SUBDIVISION COMMITTEE
METROPOLITAN AREA PLANNING
COMMISSION

STAFF REPORT
(Preliminary Plat)

CASE NUMBER: S/D 88-37 - NEW WESTERN 3RD ADDITION

VICINITY MAP:

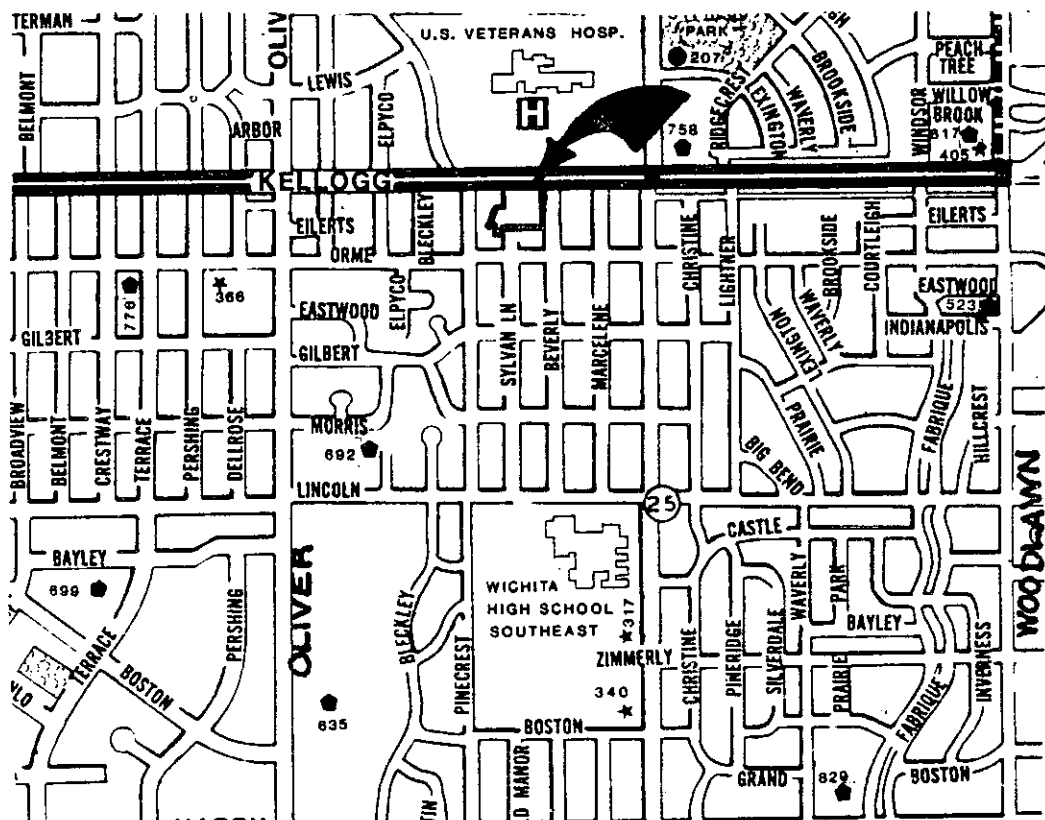
- A. The applicant shall guarantee the abandonment of the sanitary sewer lateral existing in the 20-foot, north/south utility easement that is to be vacated by this replat.

- B. The applicant shall guarantee the construction of the hammerhead turnaround for Sylvan Lane.
- C. The applicant shall guarantee the storm sewer construction required by this plat.

- D. The applicant shall submit a sidewalk certificate stating that a sidewalk will be constructed on the west side of Beverly Drive at the time of site development. (commercial zoning)

- F. The applicant shall guarantee the closure of one curb cut to Kellogg and one curb cut to Beverly Drive. These guarantees are needed in order to assure that the curb cuts, in excess of the access control being platted, will be closed.

- I. The final plat shall indicate the following access controls to perimeter streets:
 - 1. "Complete access control" to Sylvan Lane across the south line of the lot.

- 2. "Complete access control" to Beverly from the south 60 feet of the lot.

3. "Access control except for two openings" to Beverly from the north 280 feet of the lot.
- J. On the final plat, the word "parking" shall be deleted from the labeling of the "64-foot drainage and utility easement".

- K. On the final plat, the 30-foot building setback from the east line of the floodway shall be extended through the 64-foot drainage and utility easement. Also, the 25-foot setback from Beverly Drive shall be extended through this easement.

- P. It appears that the platting of the 5-foot wide wall easement is not in conflict with needed utility easements except for the 60-foot long north/south leg of the proposed wall easement. This segment of the wall easement appears to be directly over an existing sewer lateral and manhole. The final plat shall not indicate the north/south portion of the wall easement on top of the utility easement. It is suggested that the wall easement be moved to the east, adjacent to the east line of the utility easement.
